ADDENDUM NO. 1

April 18, 2017

TO THE CONTRACT DOCUMENTS FOR
PIEDMONT HILLS HIGH SCHOOL
Building D Science & Classroom Buildings
for the
EAST SIDE UNION HIGH SCHOOL DISTRICT

DSA # 01-116180 - FILE NO. 43-H10

INTERIOR ELEVATION 1/4" = 1'-0" H

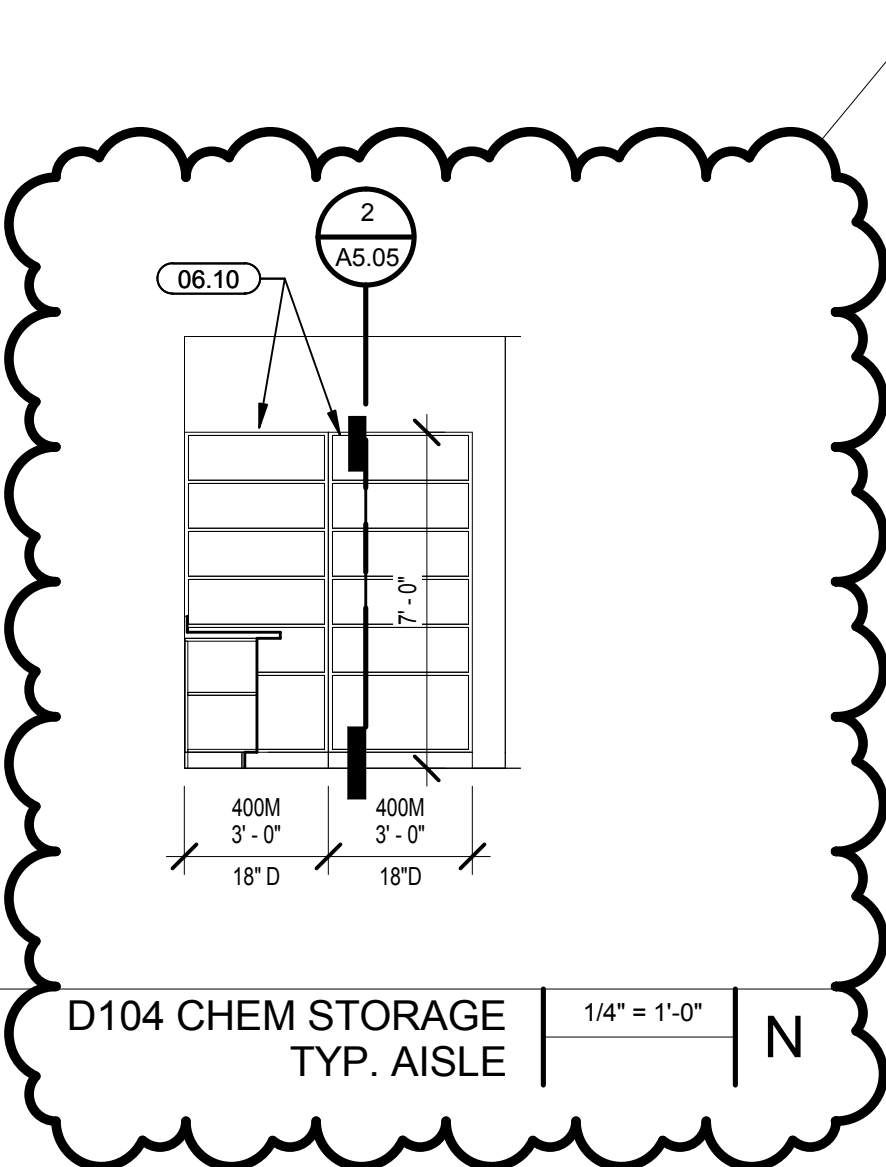
ITEM NO. AD1 -11 Remove sheet A5.05, Interior Elevations. Replace with sheet A5.05, Interior Elevations.

- a) Revise 01/5.05 Enlarged Plan – D104 Chem Storage casework.
- b) Revise interior elevations J, K, L and M to depict casework revisions.
- c) Provide casework per additional elevation N.

SECOND FLOOR LIGHTING PLAN

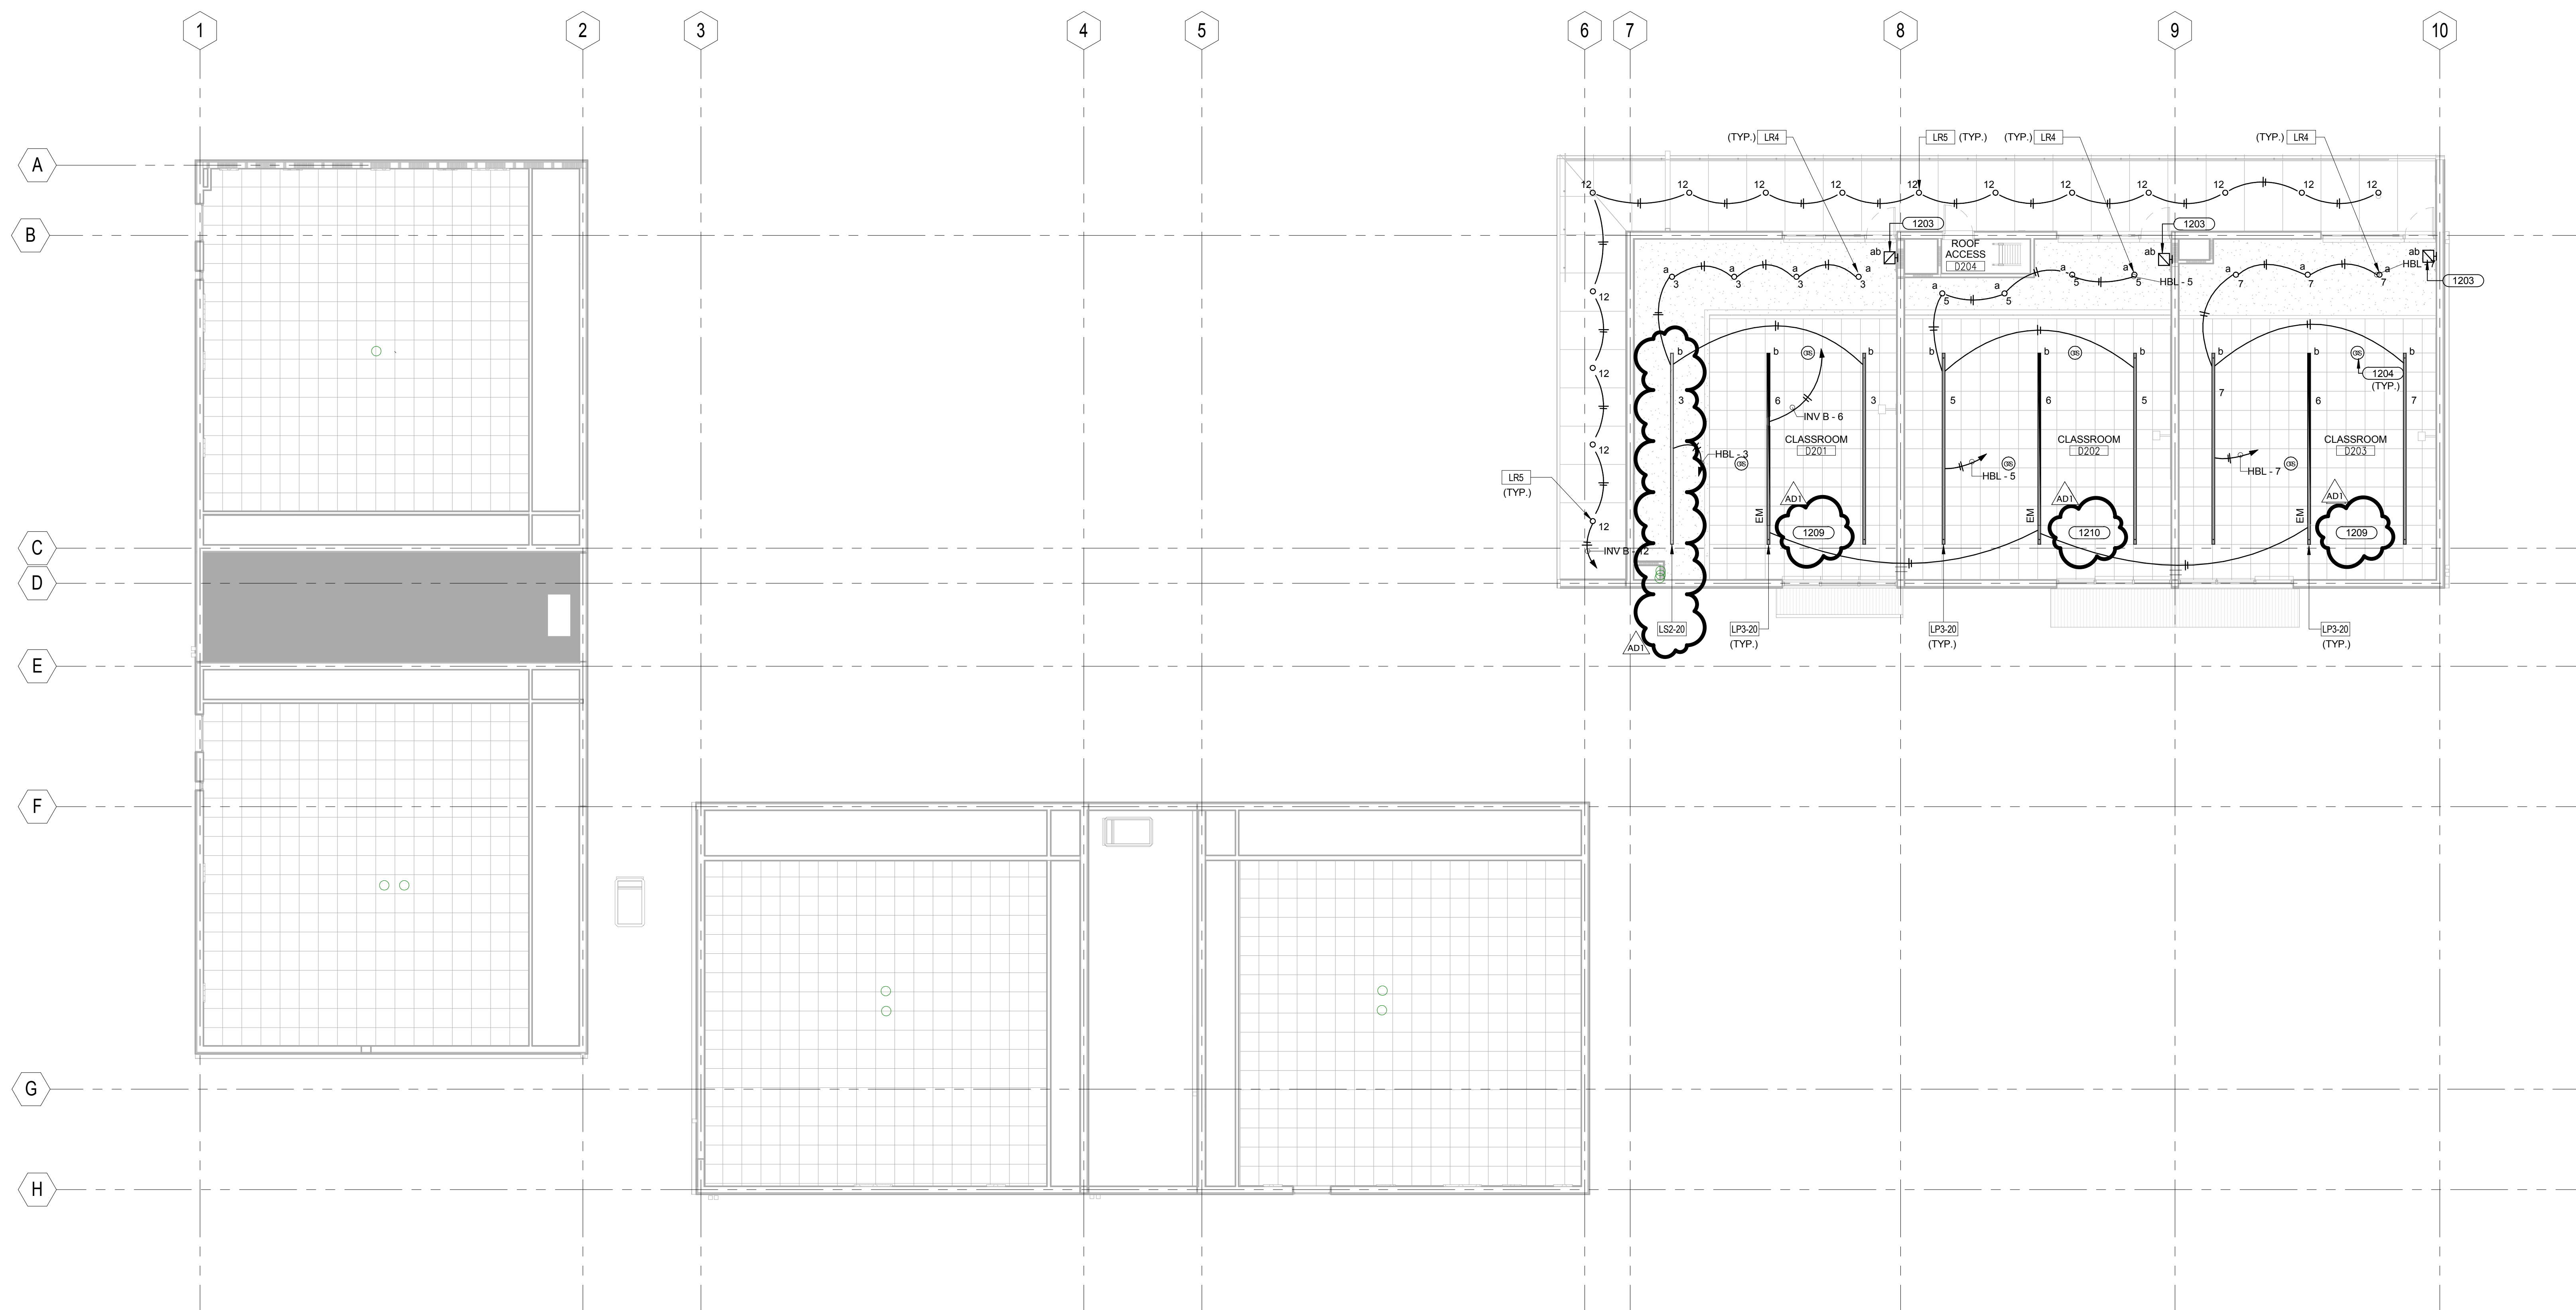
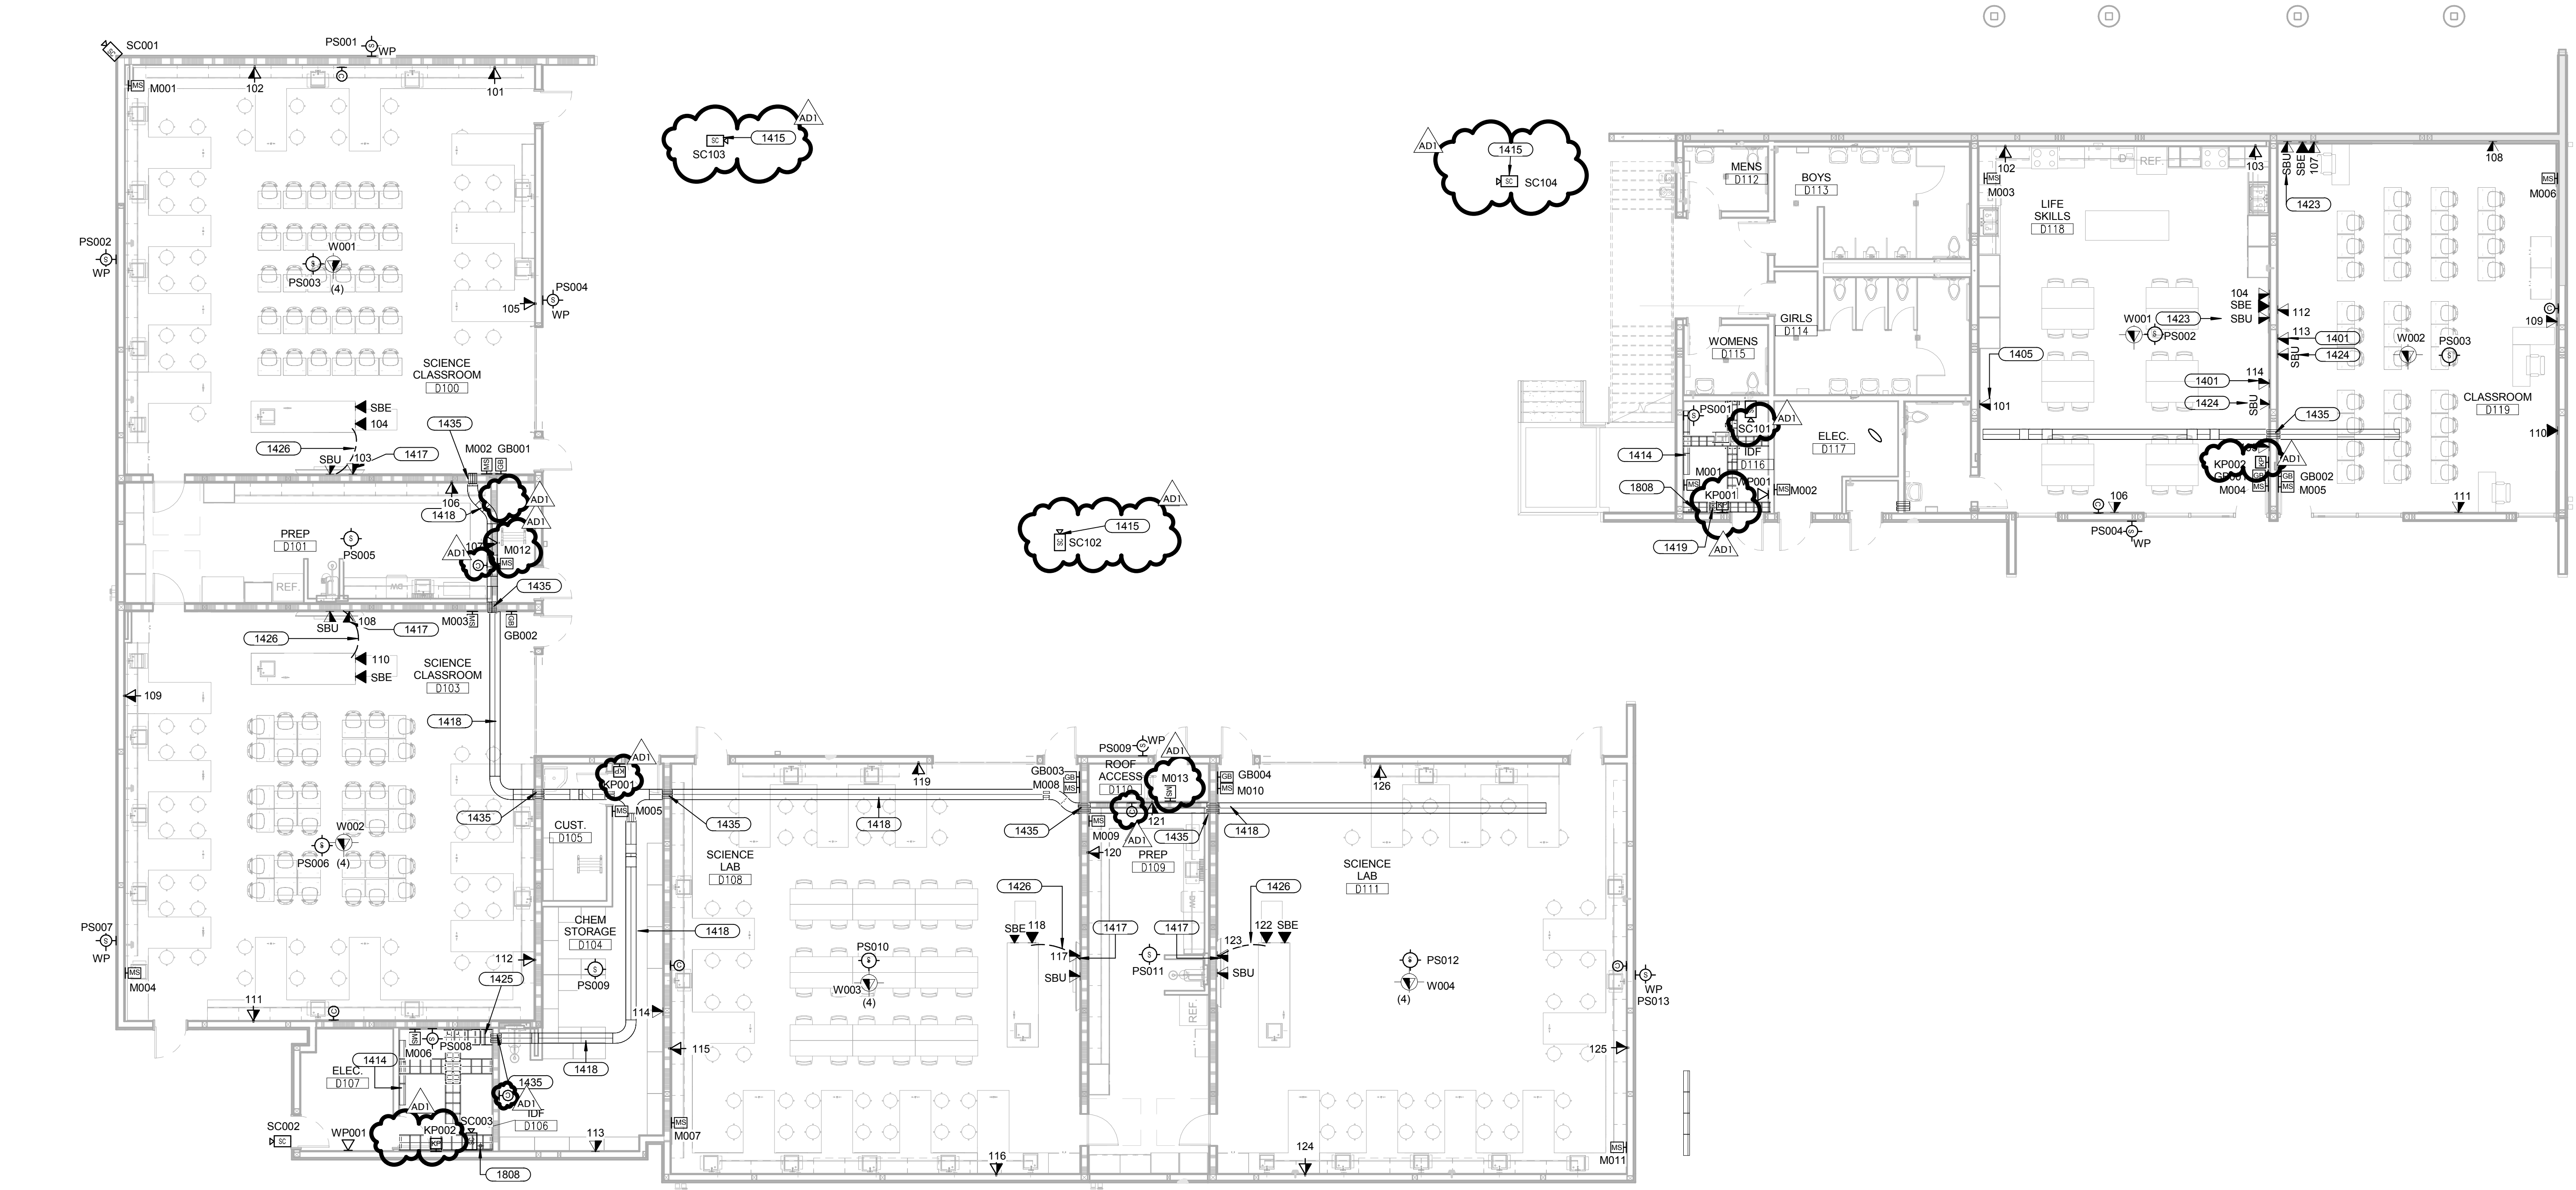
ITEM NO. AD1 -19 Delete sheet E2.12. Replace with sheet E2.12, Second Floor Lighting Plan for LS2 mounting.

- a) Revise keynotes 1209 and 1210.

TECHNOLOGY
FLOOR PLAN - 1ST
LEVEL

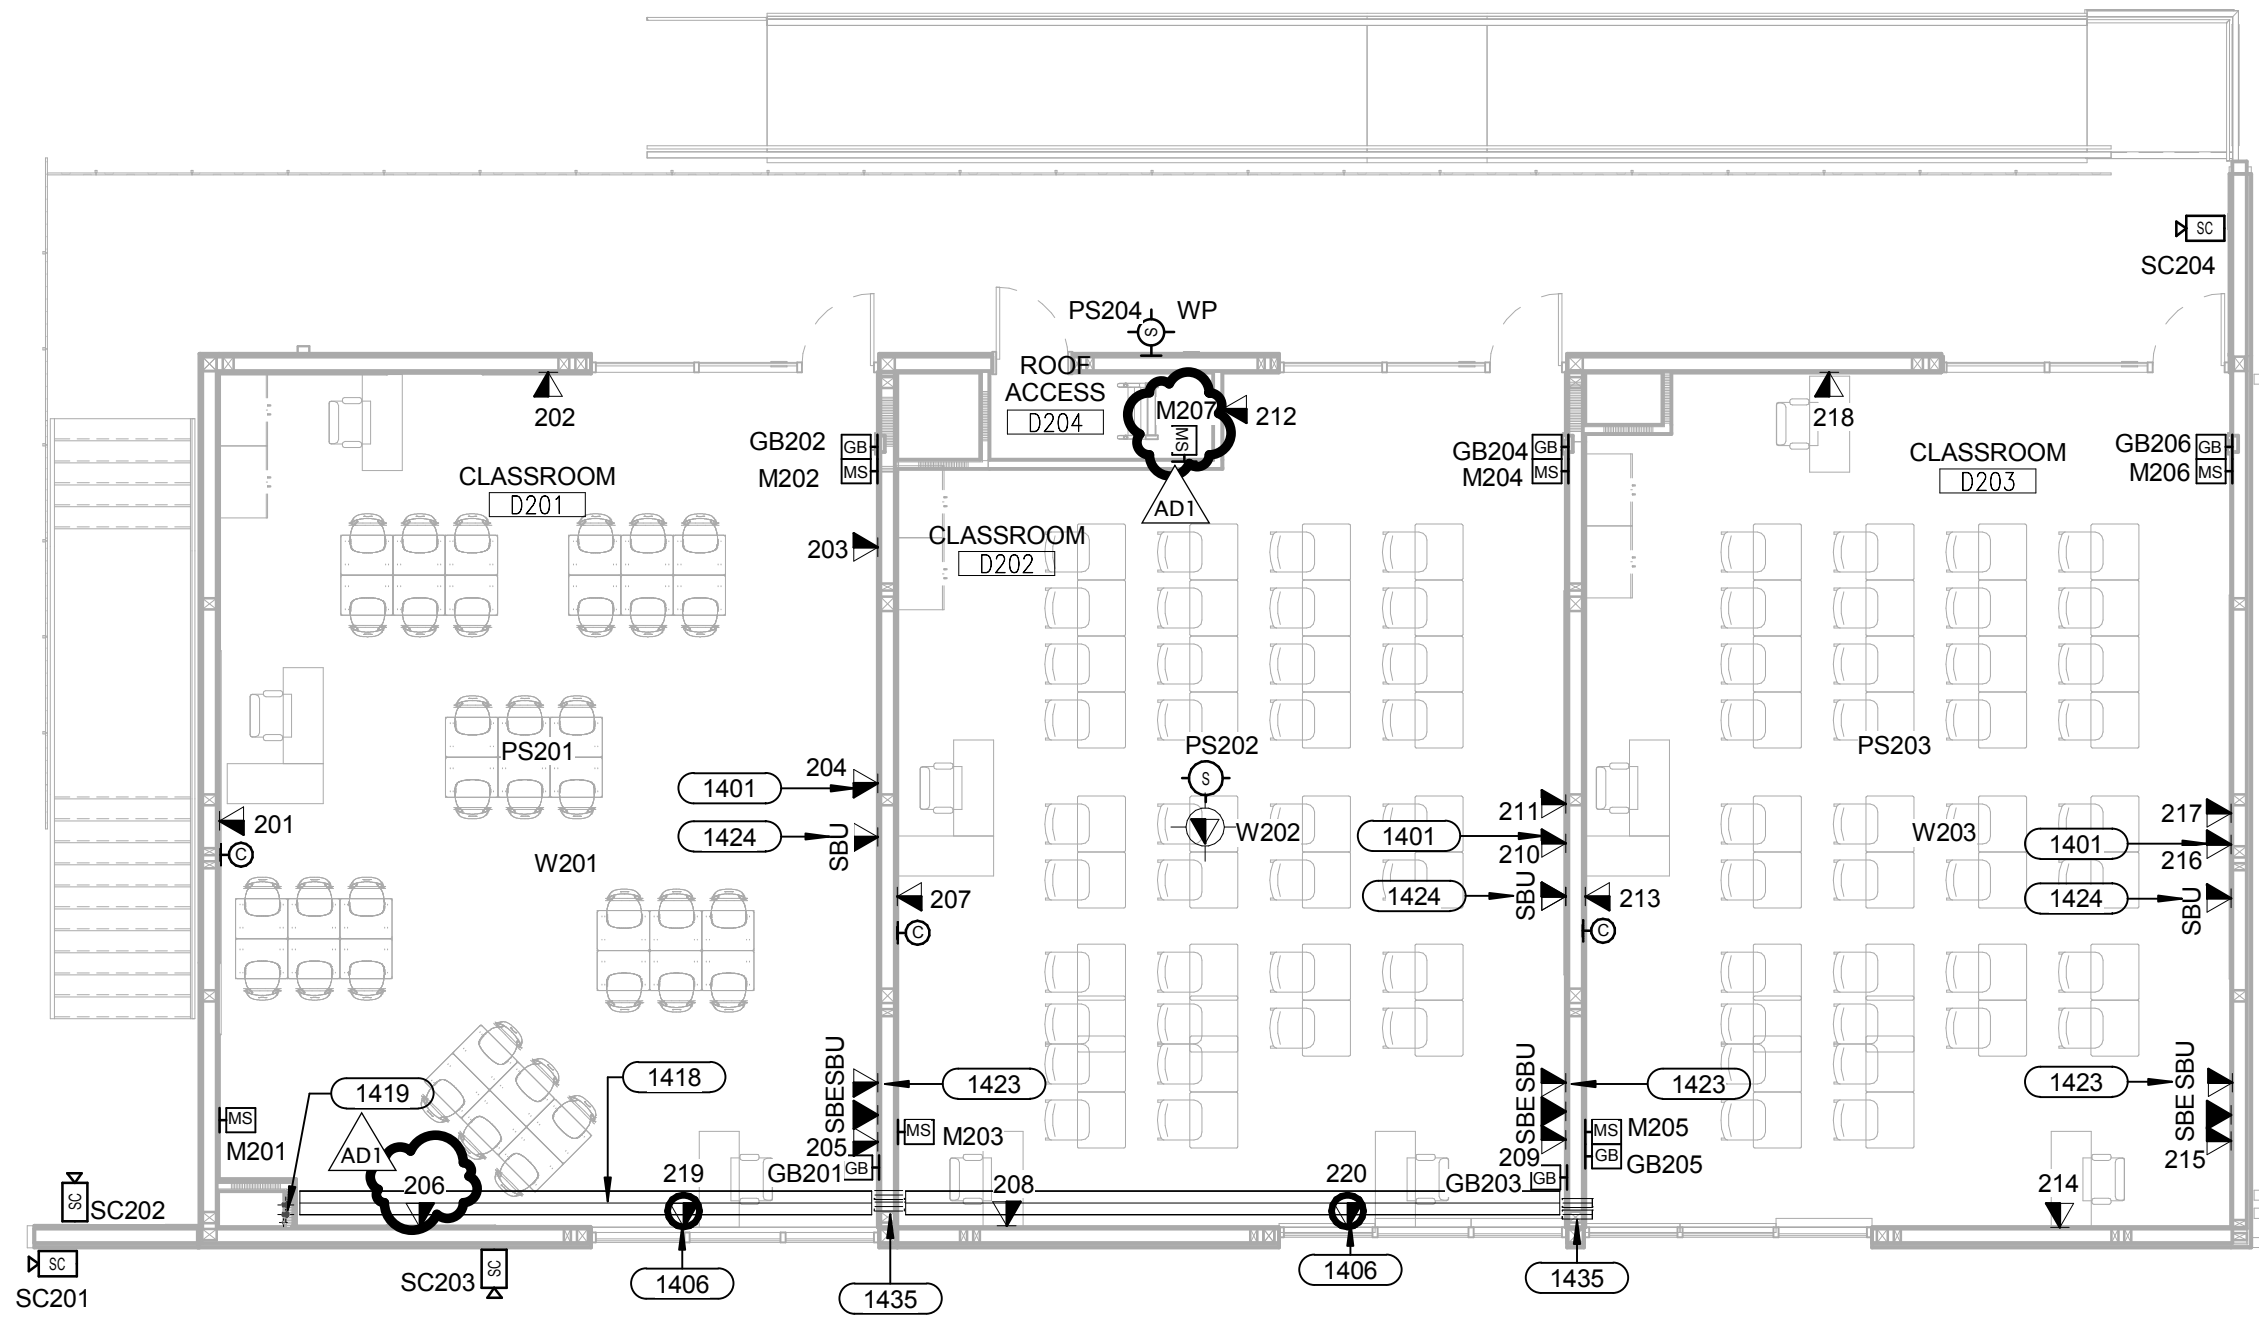
ITEM NO. AD1 -20 Delete sheet T2.11. Replace with sheet T2.11 Technology Floor Plan – 1st Level

- a) Relocated security key pads
- b) Provide clocks and speakers in Prep Room 101, Chem Storage D104, and Prep Room 109
- c) Provide motion sensors in Roof Access rooms.
- d) Revise camera labels per revisions.
